CS Memorandum No. 1325

Subject: Configuration Management Board Meeting No. 106

CMB Meeting Minutes #106

REFERENCE: Project No. M544.1, Contract No. 149 Task 1-8.02
Final Design

CONTRACT NO.	1252
SFMTA CONTROL NO.	CL-18001
DRAWING NO.	UT-701
SHEET NO.	1

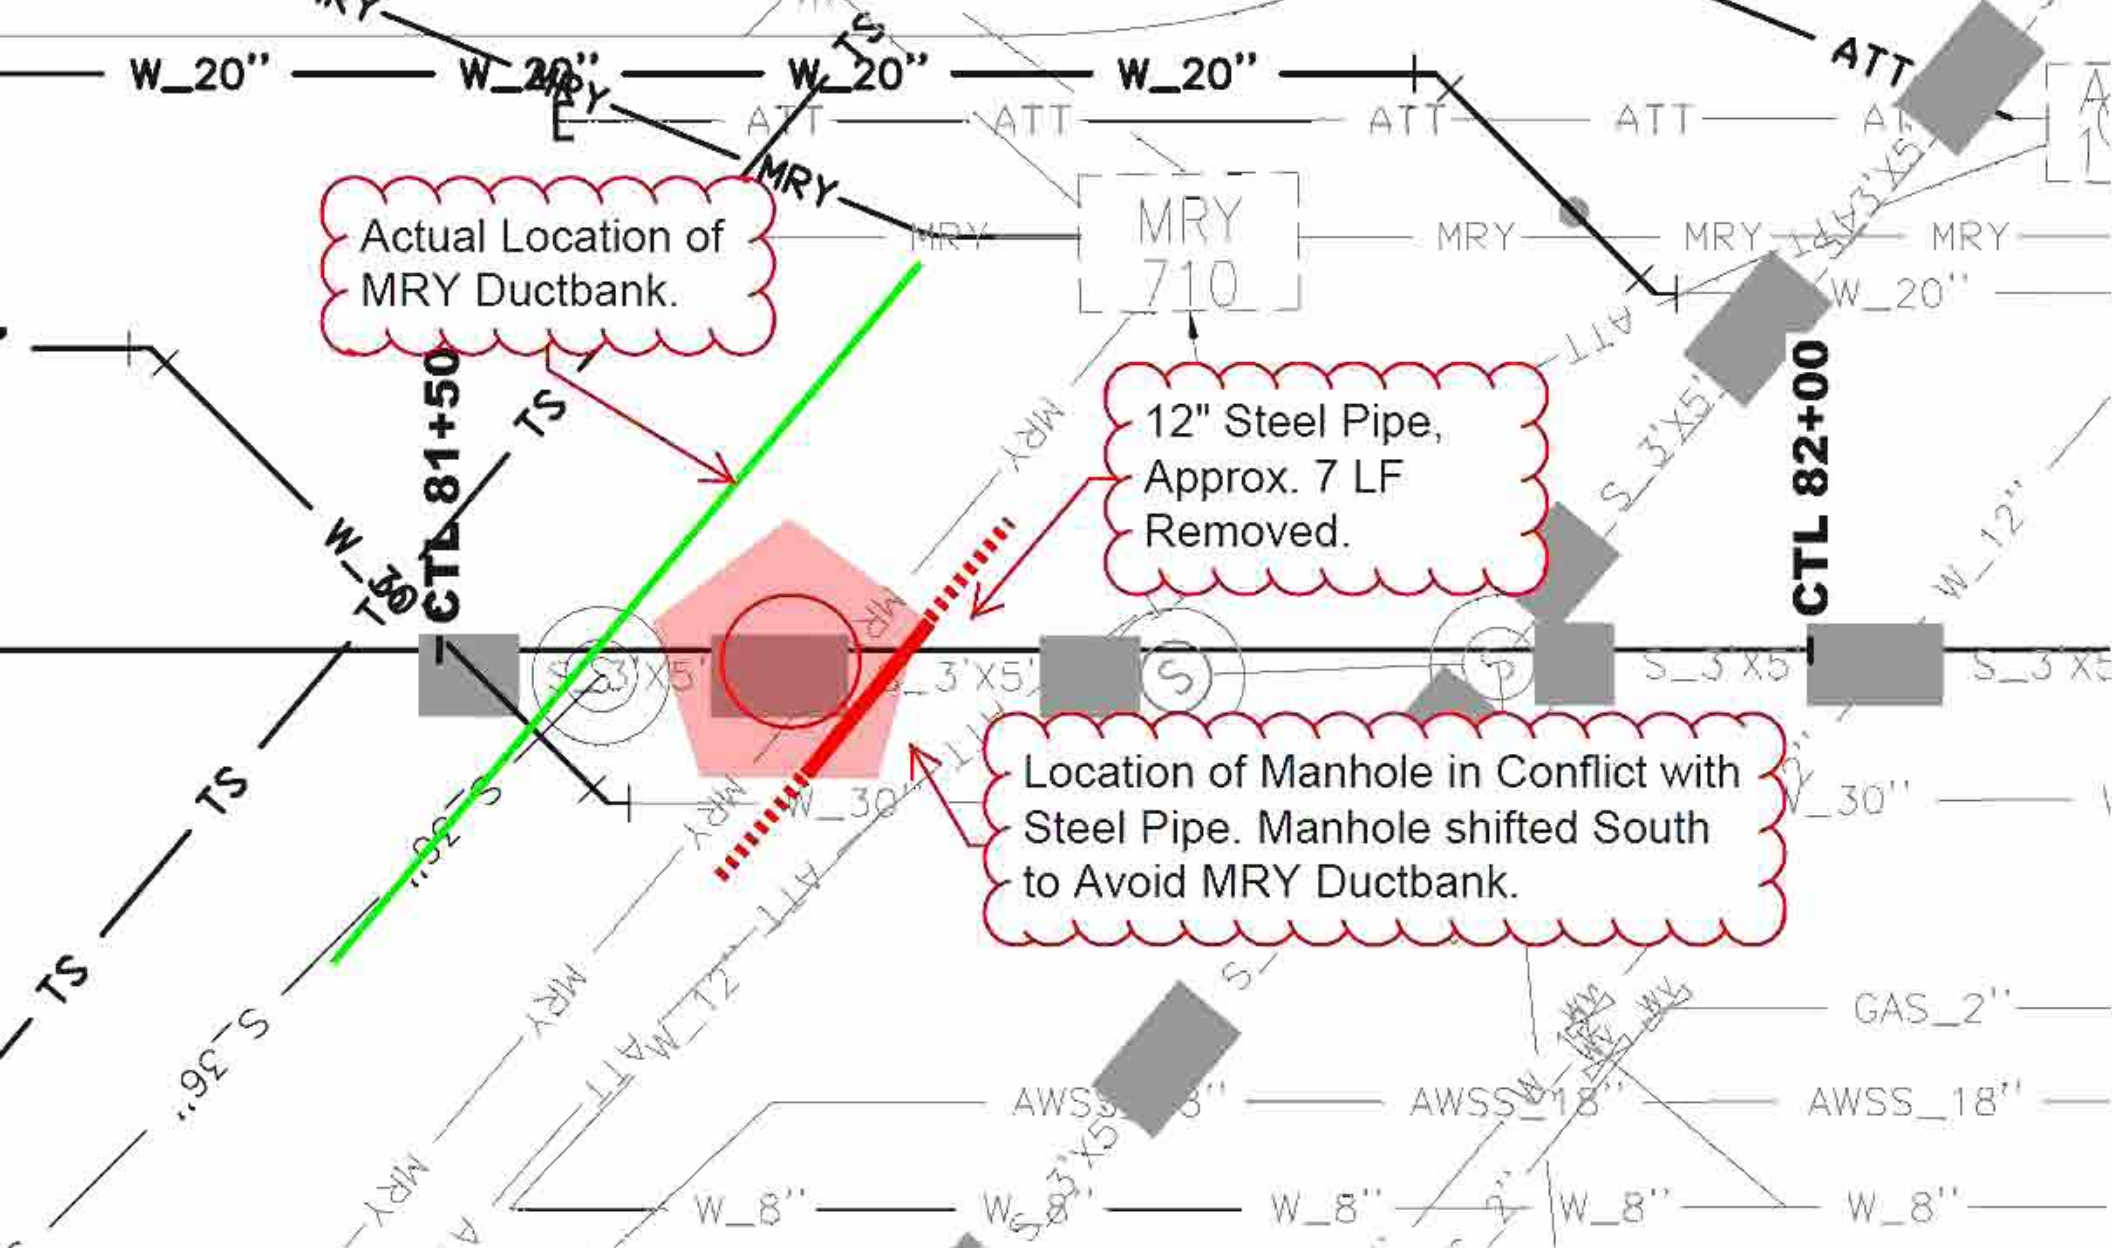
Actual Location of MRY Ductbank.

12" Steel Pipe, Approx. 7 LF Removed.

CONTRACT NO. 1252	
SFMTA CONTROL NO. CL-18001	
DRAWING NO. UT-701	REVISION
SHEET NO.	1

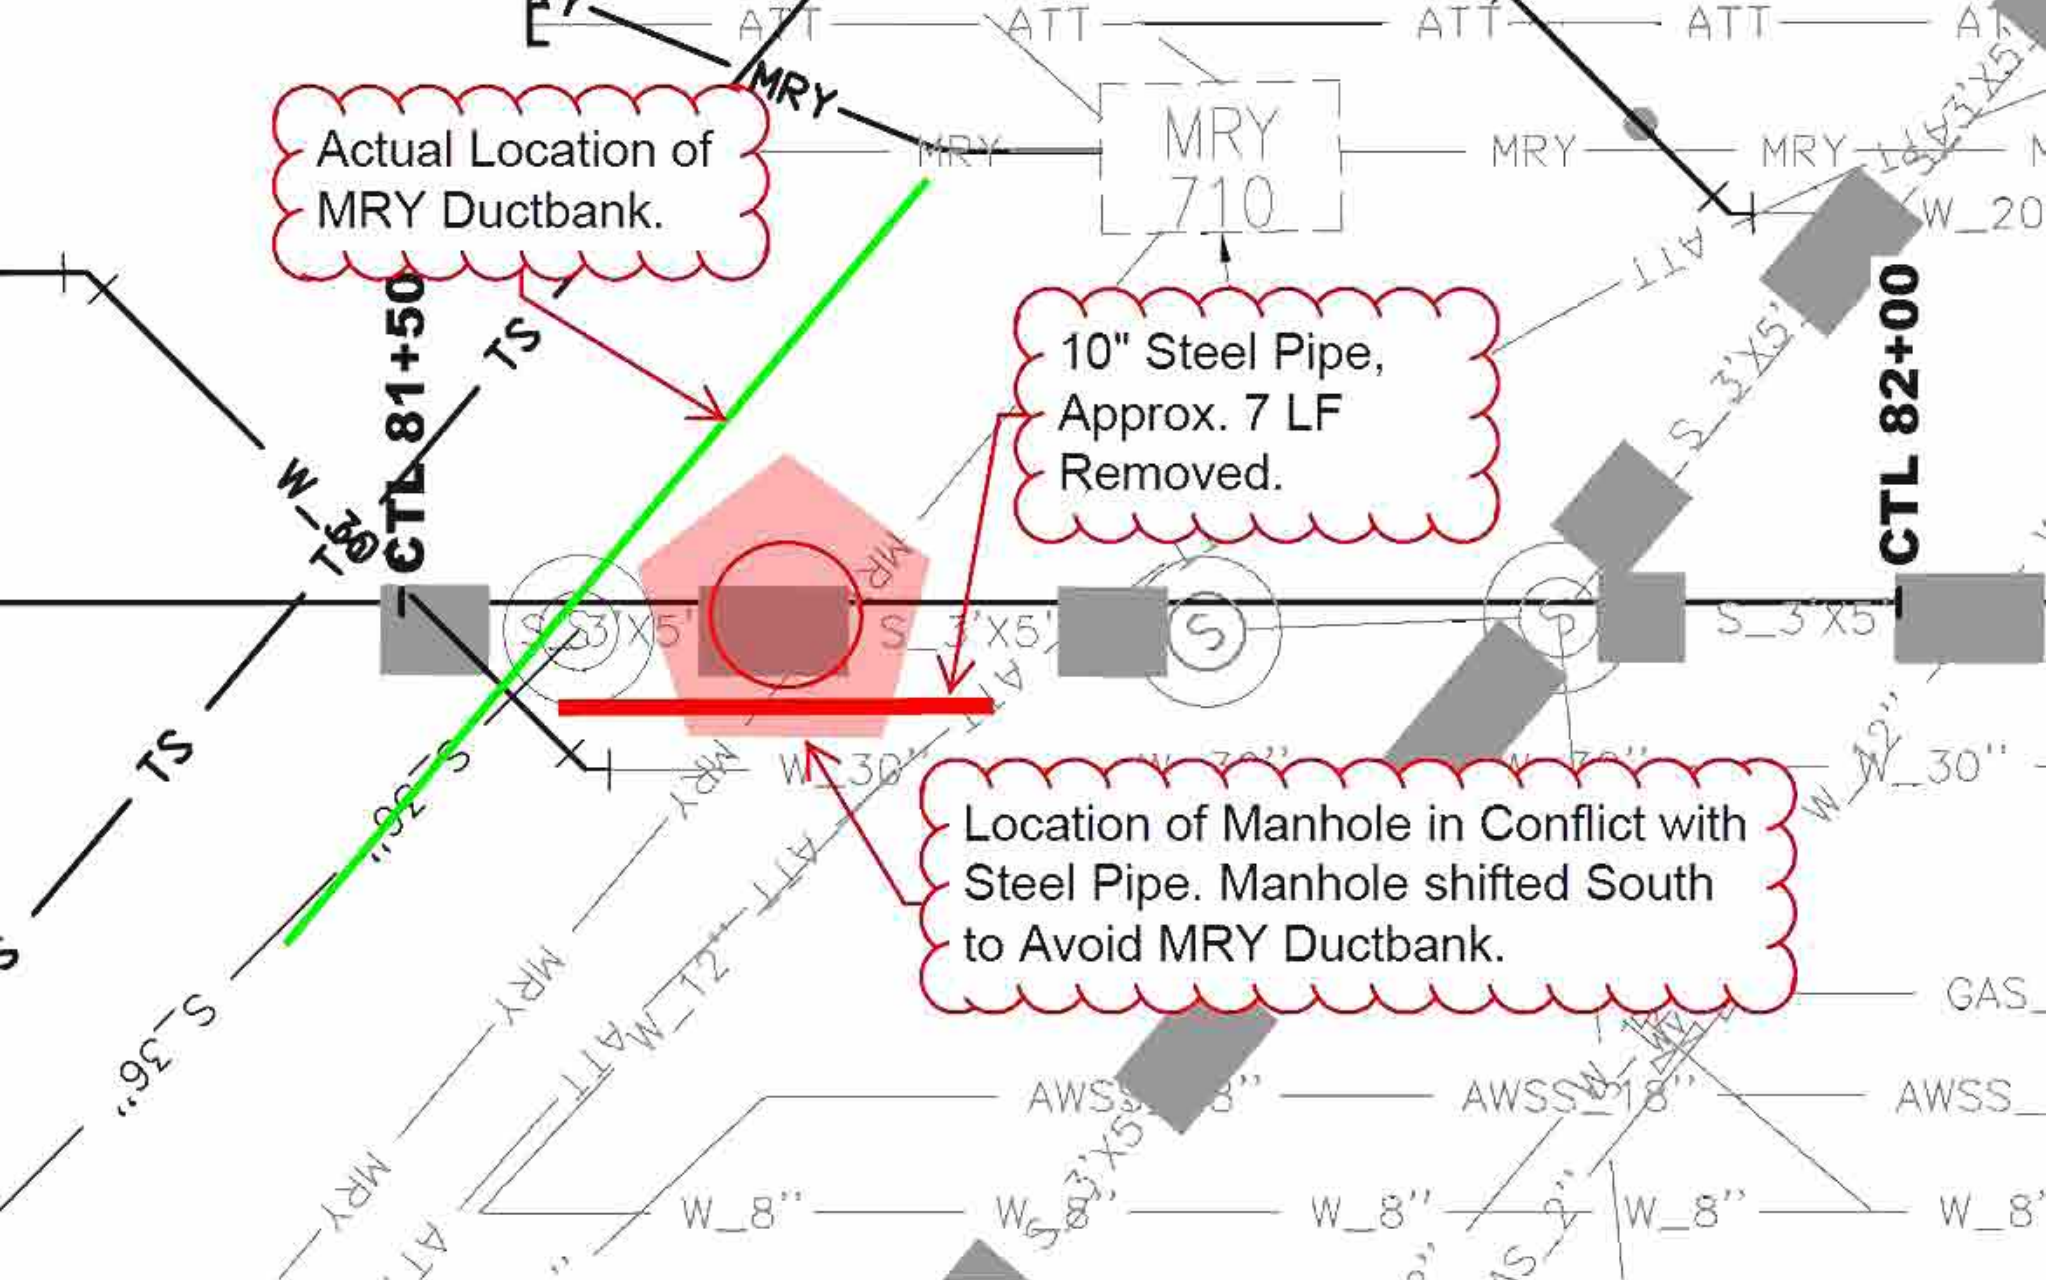
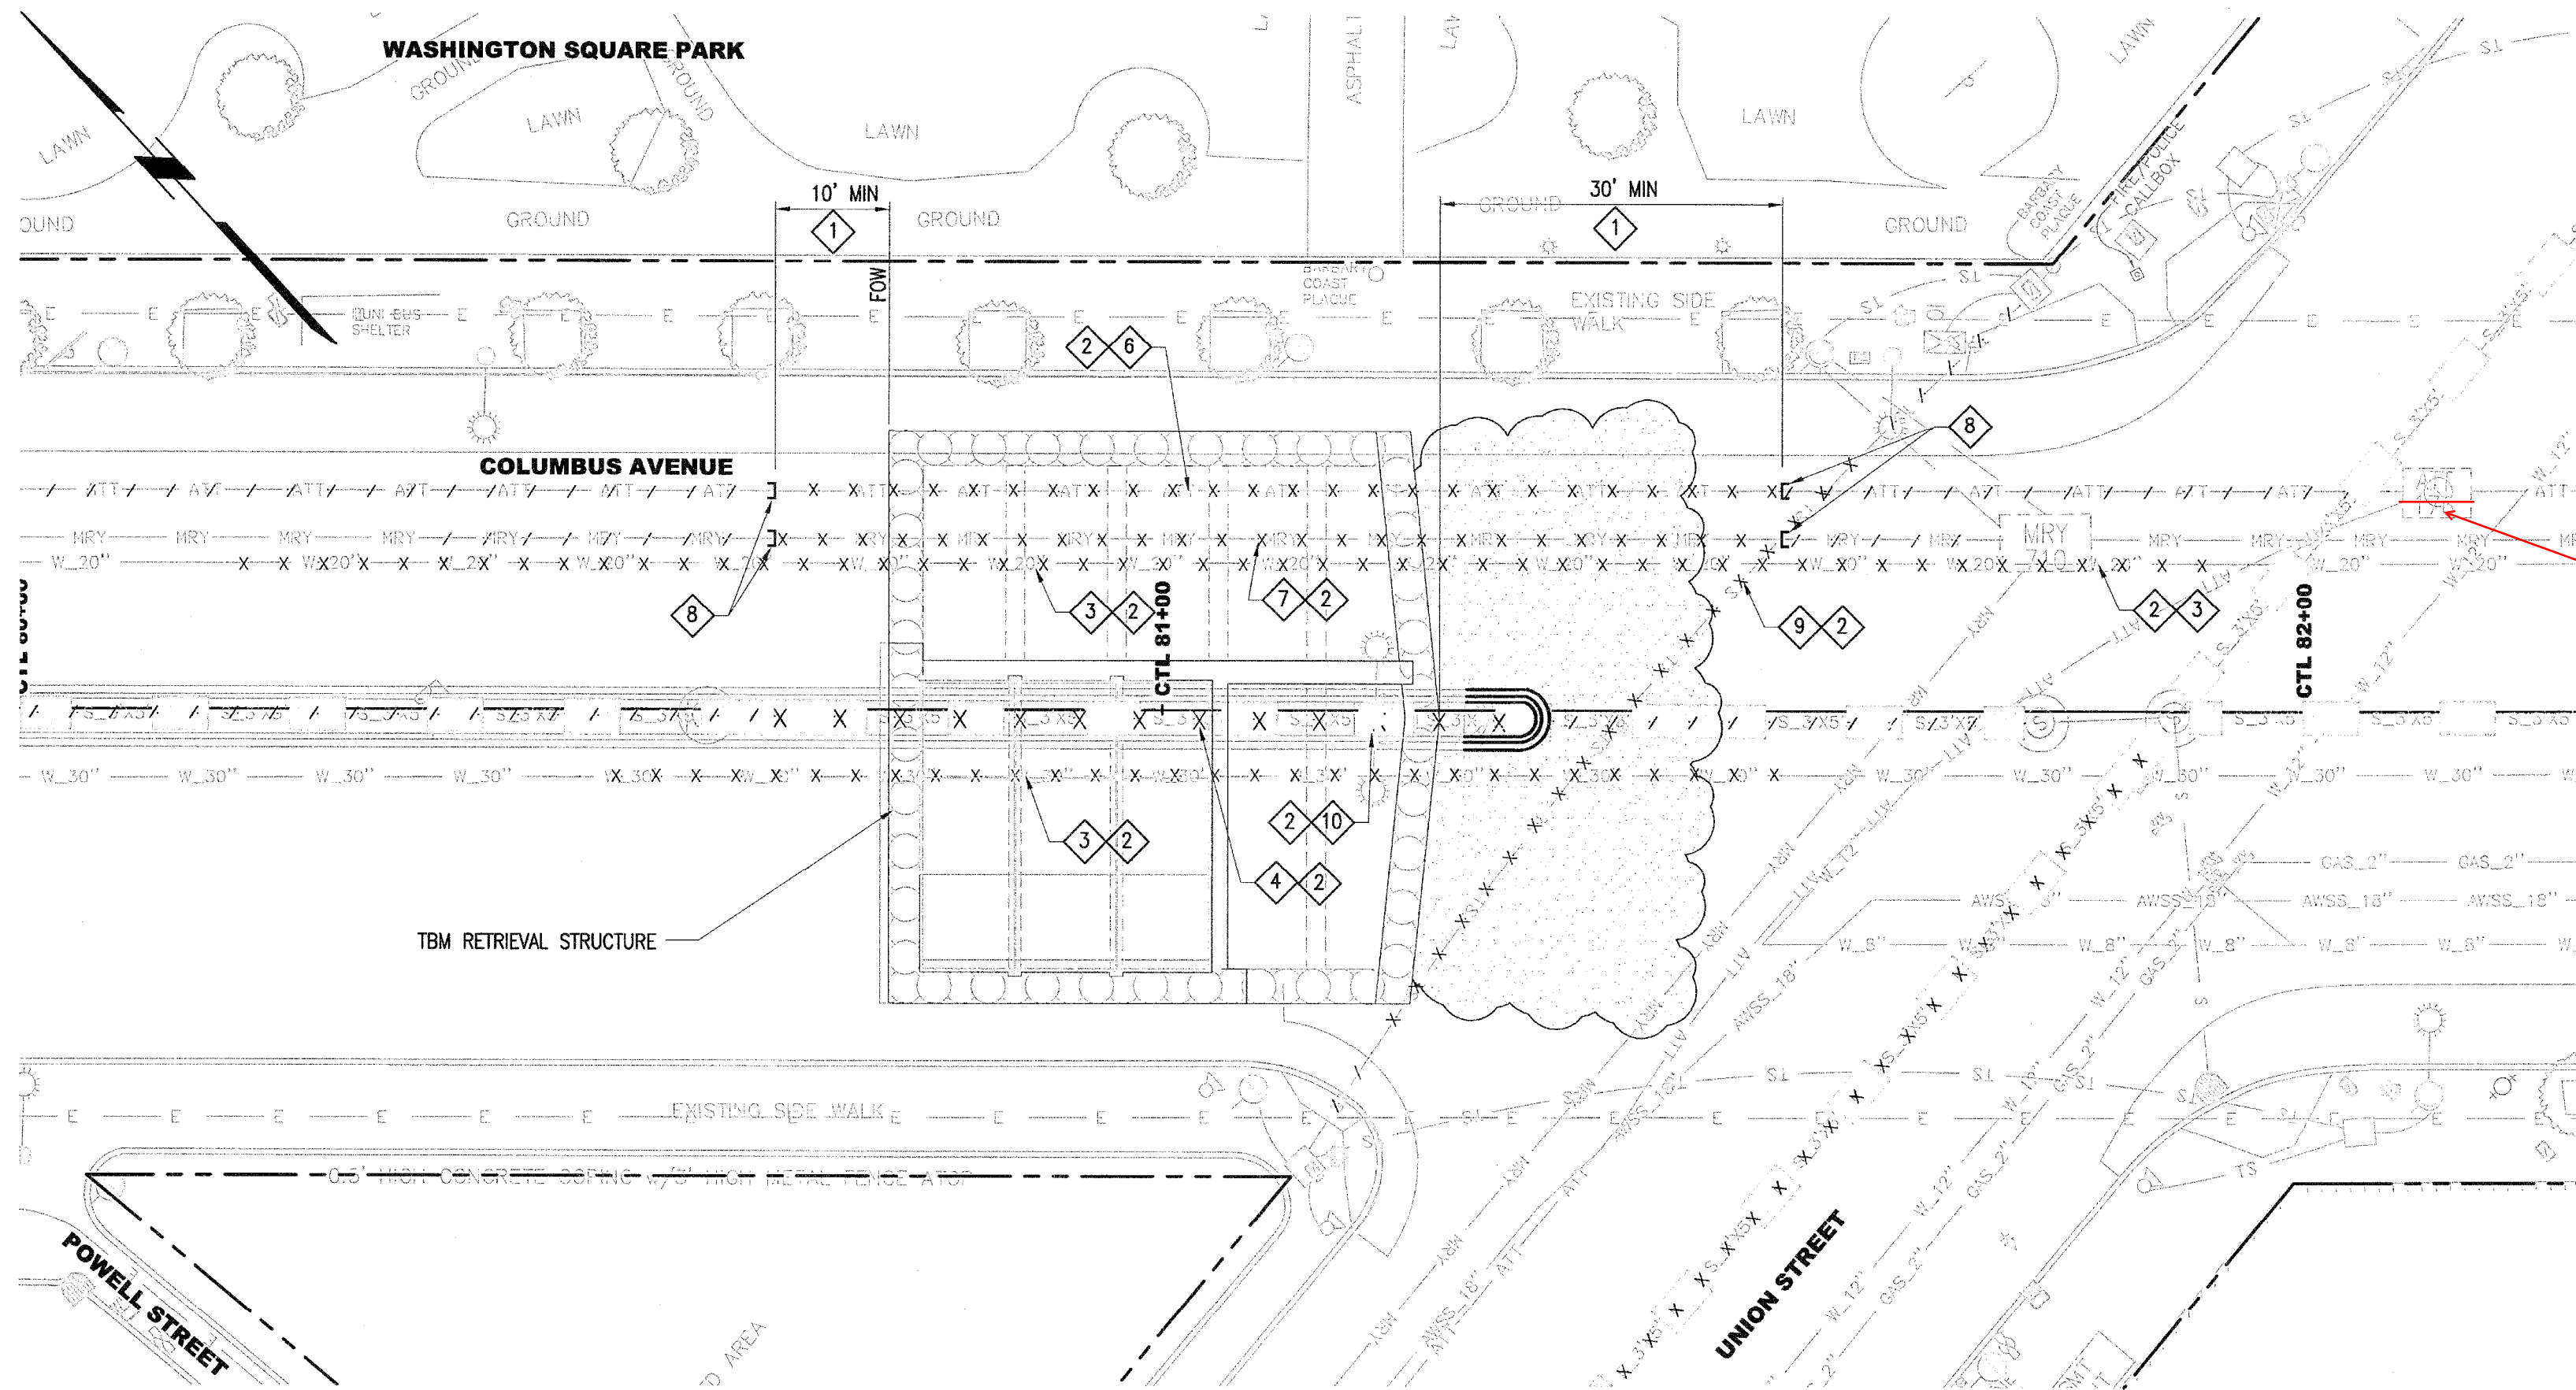
Actual Location of MRY Ductbank.

10" Steel Pipe, Approx. 7 LF Removed.

Location of Manhole in Conflict with Steel Pipe. Manhole shifted South to Avoid MRY Ductbank.

Facts: On November 21st 2012, The Contractor removed an abandoned 12” steel pipe from AT&T vault No.176 at the intersection of Union Street and Columbus Avenue. The removal of the 12” line was needed to provide access for AT&T to make connections inside this vault. A time extension has not been requested for this work.

Contractor Rationale for COR: The contractor claims that the steel pipe constitutes a differing site condition, as it was not shown on the contract drawings at the time of bid.

Justification: RE has evaluated the conditions outlined in Article 3.04 and found that: conditions differ materially and conditions have caused the scope of work to increase.
